UNION ELECTRIC COMPANY

CALLAWAY PLANT, UNIT 1

AMENDMENT TO FACILITY OPERATING LICENSE

Amendment No. 36  
License No. NPF-30

Figure 3.4-2

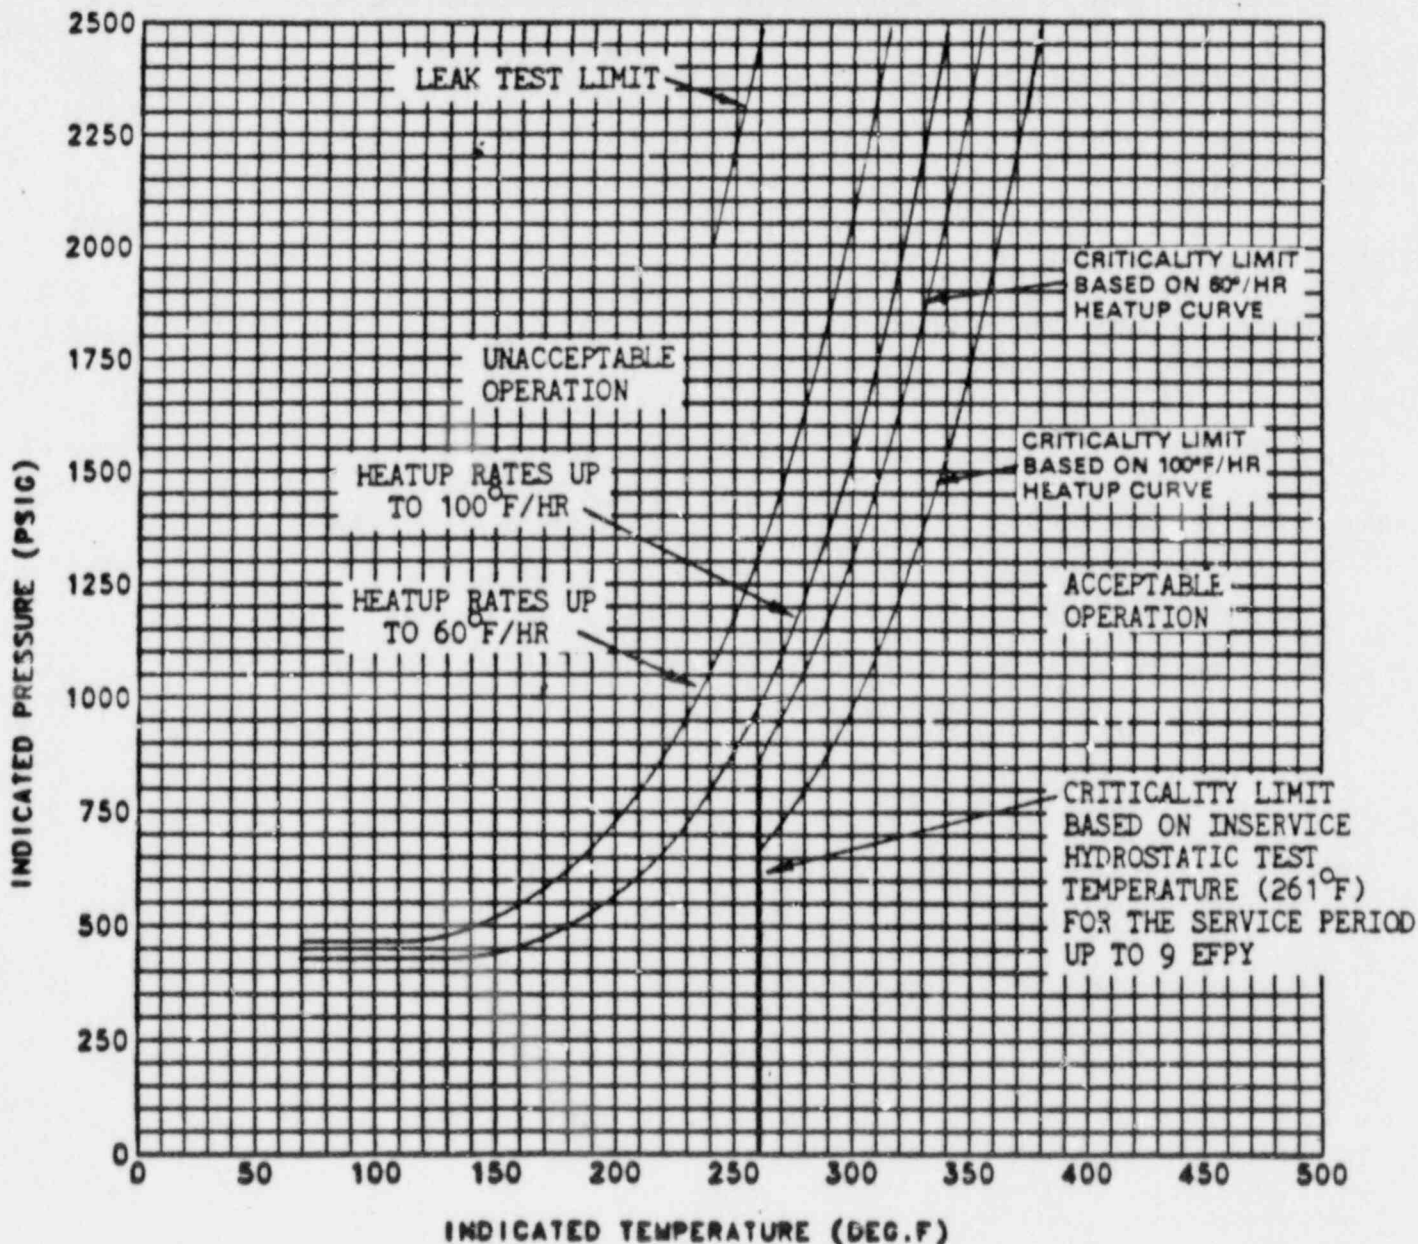
CONTROLLING MATERIAL: R.V. LOWER SHELL  
 COPPER CONTENT: 0.07 WT%  
 NICKEL CONTENT: 0.59 WT%  
 INITIAL RT<sub>NDT</sub>: 50°F

RT<sub>NDT</sub> AFTER 9 EPFY: 1/4T, 116.4°F  
 3/4T, 108.3°F

CURVES APPLICABLE FOR HEATUP RATES UP TO 100°F/HR FOR THE SERVICE PERIOD UP TO 9 EPFY AND CONTAINS MARGINS OF 10°F AND 60 PSIG FOR POSSIBLE INSTRUMENT ERRORS

REACTOR COOLANT SYSTEM HEATUP LIMITATIONS  
 APPLICABLE FOR THE FIRST 9 EPFY.  
 UPDATED TO 3565 MWt.

FIGURE 3.4-3

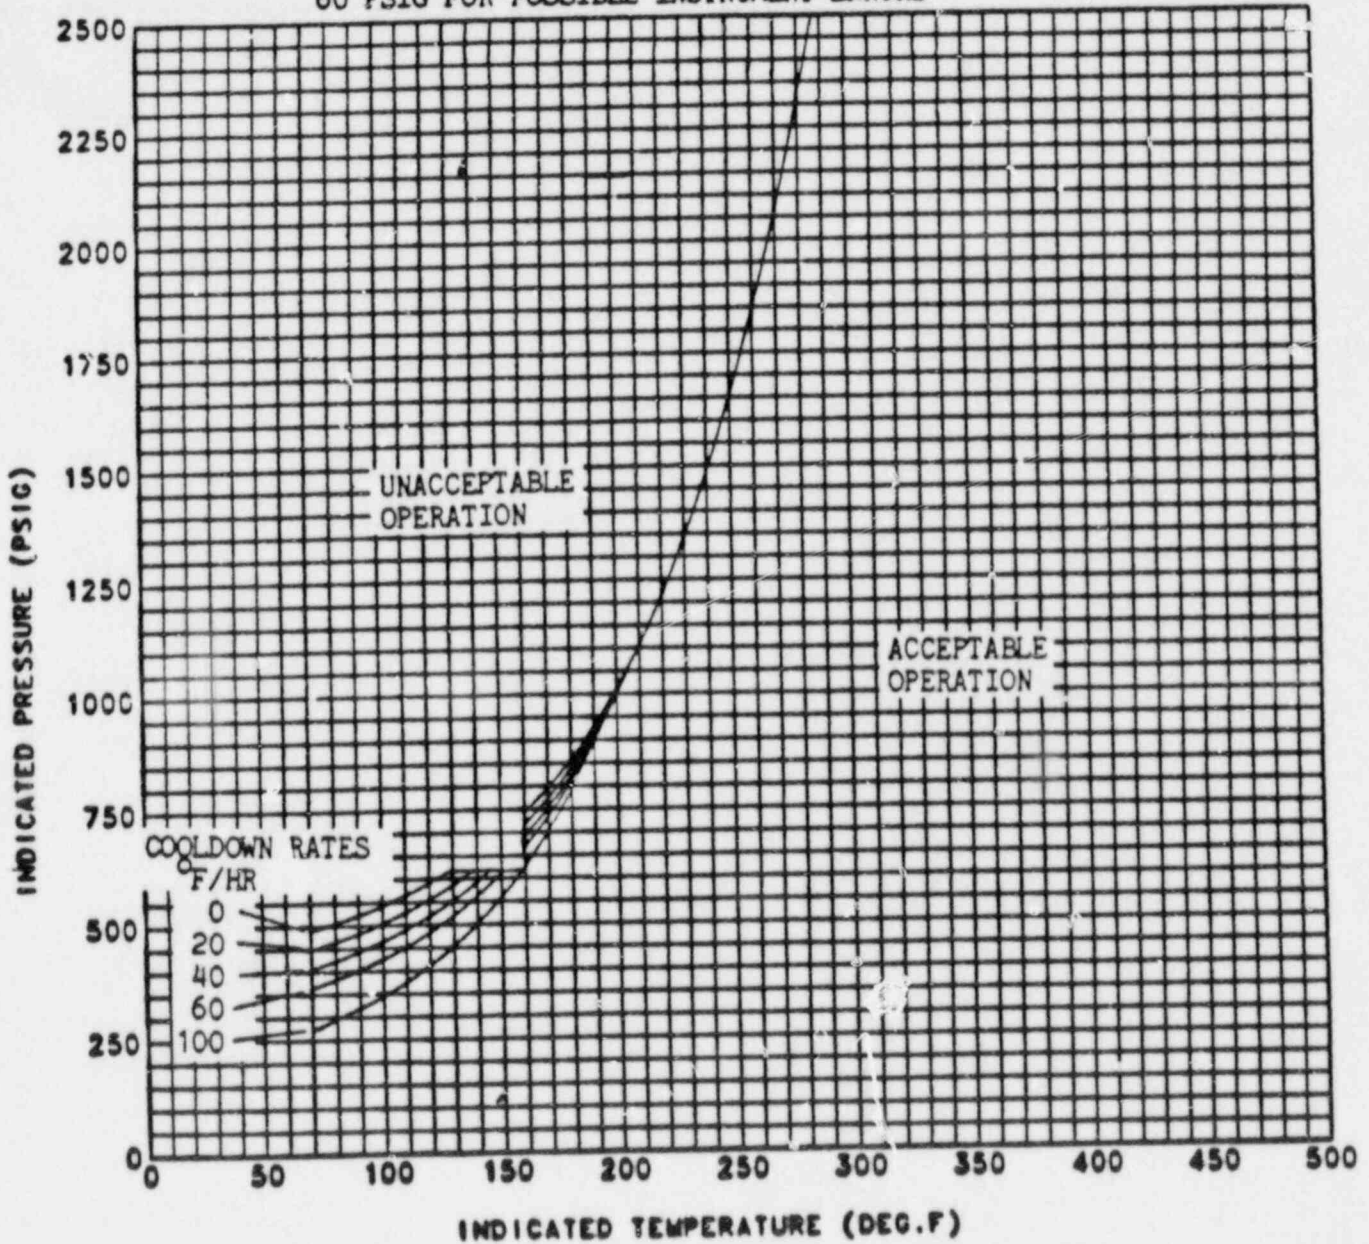
CONTROLLING MATERIAL: R.V. LOWER SHELL  
COPPER CONTENT: 0.07 WT%  
NICKEL CONTENT: 0.59 WT%  
INITIAL RT<sub>NDT</sub>: 50°F

RT<sub>NDT</sub> AFTER 9 EFPY: 1/4T, 116.4°F  
3/4T, 108.3°F

CURVES APPLICABLE FOR COOLDOWN RATES UP TO 100°F/HR FOR THE SERVICE PERIOD UP TO 9 EFPY AND CONTAINS MARGINS OF 10°F AND 60 PSIG FOR POSSIBLE INSTRUMENT ERRORS

REACTOR COOLANT SYSTEM COOLDOWN LIMITATIONS  
APPLICABLE FOR THE FIRST 9 EFPY.  
UPRATED TO 3565 Mwt.

FIGURE 3.4-4

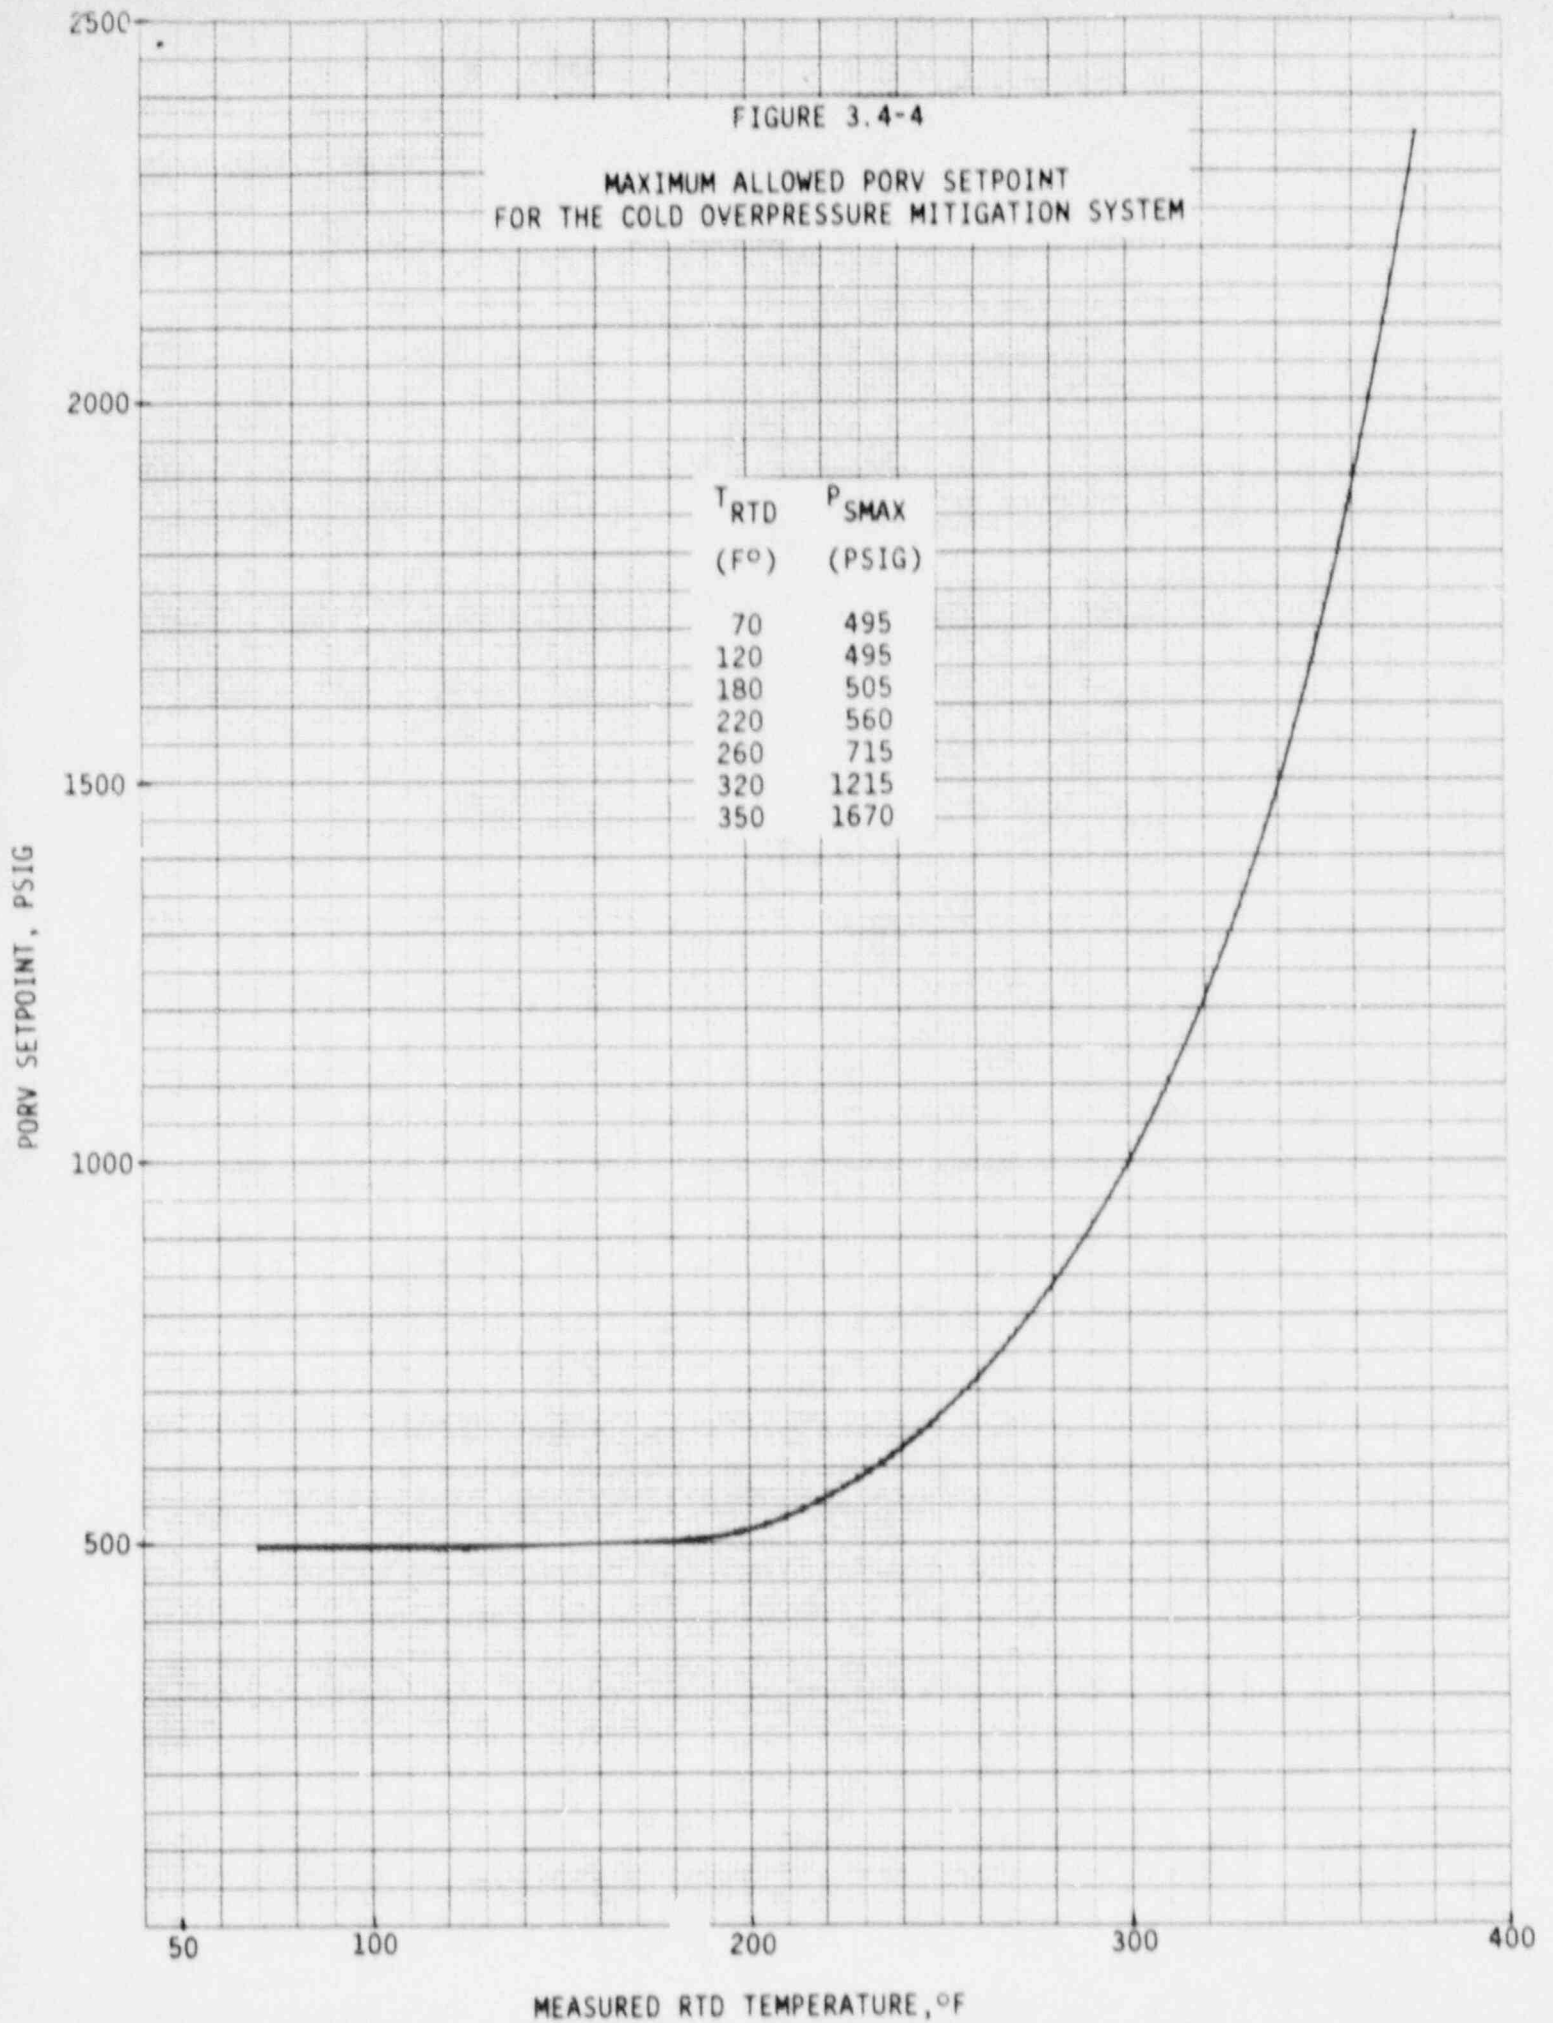
MAXIMUM ALLOWED PORV SETPOINT  
FOR THE COLD OVERPRESSURE MITIGATION SYSTEM

T <sub>RTD</sub> (F°)	P <sub>S MAX</sub> (PSIG)
70	495
120	495
180	505
220	560
260	715
320	1215
350	1670
